### <u>AIR - H.P. COMPRESSOR - INTRODUCTION OF SOLENOID VALVES WITH IMPROVED ELECTRICAL</u> <u>BONDING - CATEGORY CODE 6 - MOD.ENG-75-0014</u>

### AIR - HP COMPRESSOR - INTRODUCTION OF SOLENOID VALVES WITH ELECTRICAL BONDING

### Dunlop Modifications E552, E553 and E554

Location of Solenoid Valve Stage 10 Bleed Fig.1 (Sheet 1 of 3)

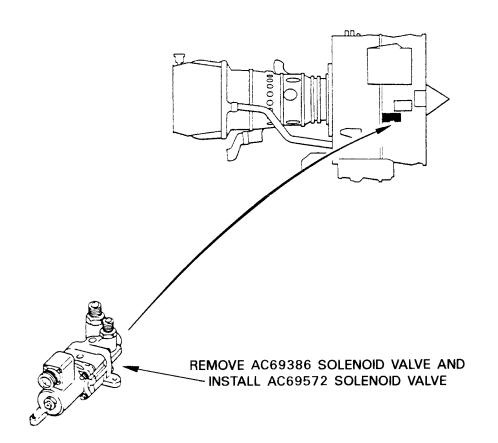
It is a requirement that the electrical resistance between the pipe unions and the mounting surface of the solenoid valves is at maximum 25m ohms.

Incorporation of the changes introduced by this Service Bulletin are designed to improve the electrical bonding of the solenoid valves.

The modification contained in the Dunlop Service Bulletin allows the anodizing at the pipe union and the mounting surface to be replaced by Alocrom to maintain the electrical resistance between the pipe union and the mounting surface of the solenoid valve within a maximum of 25m ohms.

- B. Assembly Instructions
  - (1) New AC69576, AC69572 and AC69574 stage 7 and 10 solenoid valves are interchangeable with in use stage 7 and 10 solenoid valves.
  - (2) Assemble new or re-identified AC69576, C69572 and AC69574 stage 7 and 10 solenoid valves by use of approved procedures, Engine Manual, 72-00-32, Installation.
- C. Record Instructions
  - (1) A record of accomplishment is necessary.
